APPLICATION NO.	FILING DATE	FIRST NAMED INVENTOR	ATTORNEY DOCKET NO.	CONFIRMATION NO.
10/581,720	06/05/2006	Toshiaki Shimada	740819-1147	8572
78198 Studebaker & E	7590 07/24/2009 Brackett PC	EXAMINER		
1890 Preston W	$\bar{}$		KRAUSE, JUSTIN MITCHELL	
	Suite 105 Reston, VA 20191		ART UNIT	PAPER NUMBER
·			3656	
			MAIL DATE	DELIVERY MODE
			07/24/2009	PAPER

Application No.	Applicant(s)			
	10/581,720	SHIMADA, TOSHIAKI			
Office Action Summary	Examiner	Art Unit			
	JUSTIN KRAUSE	3656			
The MAILING DATE of this communication app					
Period for Reply	Period for Reply				
A SHORTENED STATUTORY PERIOD FOR REPLY IS SET TO EXPIRE 3 MONTH(S) OR THIRTY (30) DAYS, WHICHEVER IS LONGER, FROM THE MAILING DATE OF THIS COMMUNICATION. - Extensions of time may be available under the provisions of 37 CFR 1.136(a). In no event, however, may a reply be timely filed after SIX (6) MONTHS from the mailing date of this communication. - If NO period for reply is specified above, the maximum statutory period will apply and will expire SIX (6) MONTHS from the mailing date of this communication. - Failure to reply within the set or extended period for reply will, by statute, cause the application to become

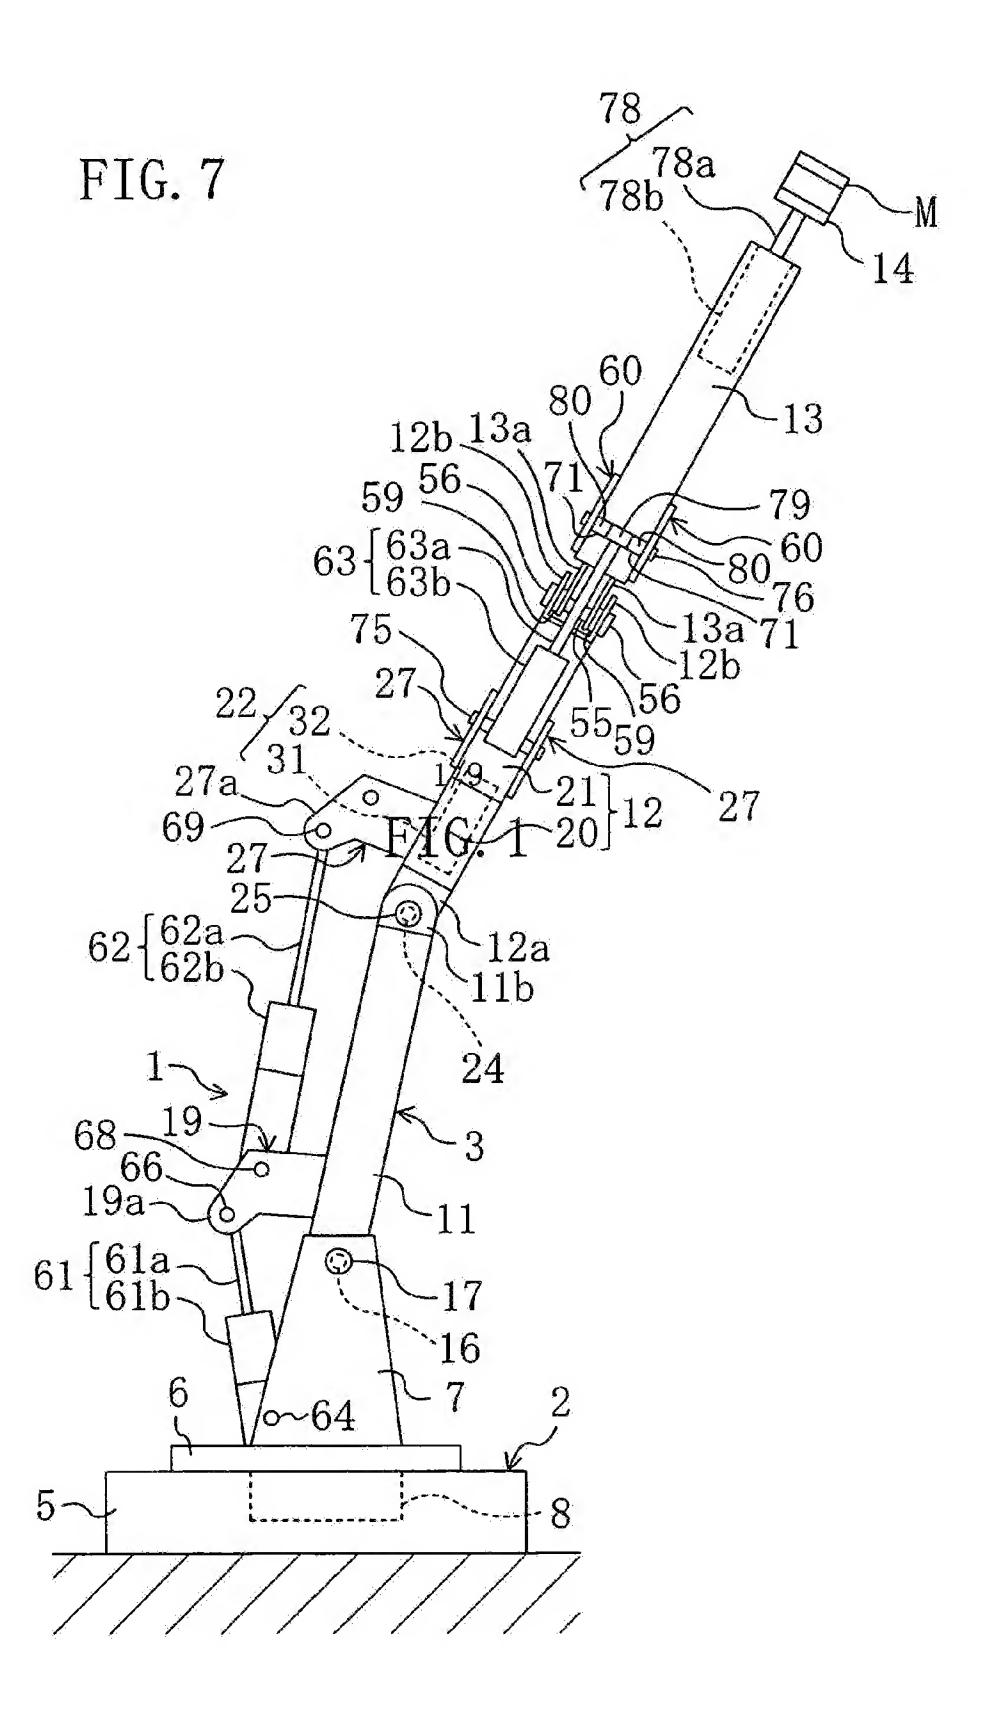
The drawings are objected to because Figure 7 as currently filed includes "1/9" and "FIG.1" in the center of the drawing (the image below depicts figure 7 as presently filed). Corrected drawing sheets in compliance with 37 CFR 1.121(d) are required in reply to the Office action to avoid abandonment of the application. Any amended replacement drawing sheet should include all of the figures appearing on the immediate prior version of the sheet, even if only one figure is being amended. The figure or figure number of an amended drawing should not be labeled as "amended." If a drawing figure is to be canceled, the appropriate figure must be removed from the replacement sheet, and where necessary, the remaining figures must be renumbered and appropriate changes made to the brief description of the several views of the drawings for consistency. Additional replacement sheets may be necessary to show the renumbering of the remaining figures. Each drawing sheet submitted after the filing date of an application must be labeled in the top margin as either "Replacement Sheet" or "New Sheet" pursuant to 37 CFR 1.121(d). If the changes are not accepted by the examiner, the applicant will be notified and informed of any required corrective action in the next Office action. The objection to the drawings will not be held in abeyance.
